RENESAS TECHNICAL UPDATE

Product Category	MPU&MCU		Document No.	TN-SH7-A571A/E	Rev.	1.00
Title	Manual correction about synchronous DRAM Interface when using 64-bit bus width (SH7750R only)		Information Category	Technical Notification		
Applicable Product	SH7750R (HD6417750R)	Lot No.	Reference Document	SH7750 Series Hardware Manual (ADE-602-124E Rev.6.0)		
		All lots

Figure Synchronous DRAM Auto-Refresh Timing with 64-Bit Bus Width
($\text{TRAS}[2:0]=001, \text{TRC}[2:0]=001$)

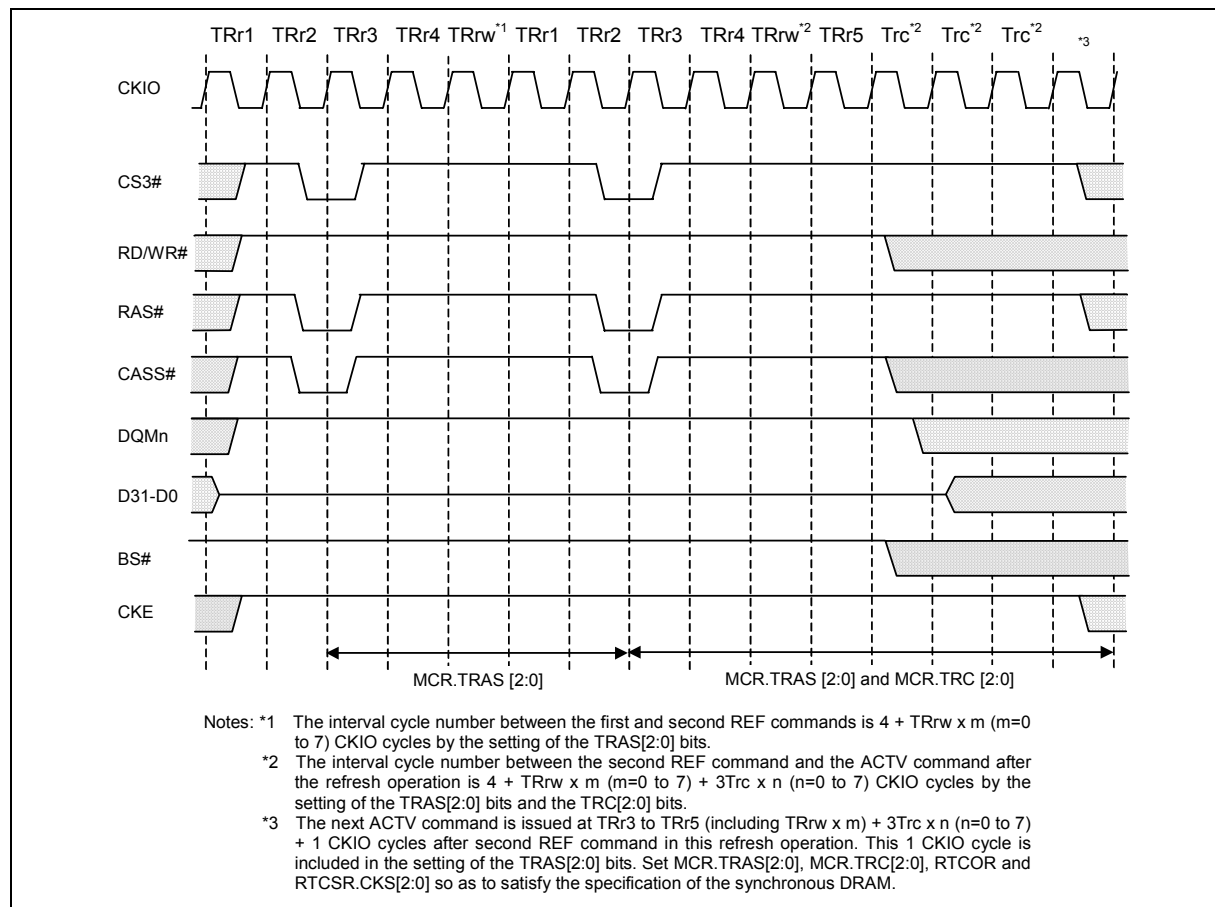
- MCR.AMX = 6: Selects the 128-Mbit or 256-Mbit address-multiplex setting for the synchronous DRAM.
- In the auto-refresh operation, the REF command is issued twice continuously in response to a single refresh request. The interval cycle number between the first and second REF commands issuance is specified by the setting of the TRAS2-TRAS0 bits in MCR, which is 4 to 11 CKIO cycles. The interval cycle number between the second REF command and the next ACTV command issuance is specified by the settings of both the TRAS2-TRAS0 bits and the TRC2-TRC0 bits in MCR in the sum total, which is 4 to 32 CKIO cycles. Set RTCOR, bits CKS2-CKS0, and MCR so as to satisfy the refresh-interval rating of the synchronous DRAM which you are using. The synchronous DRAM auto-refresh timing with 64-bit bus width is shown below figure.
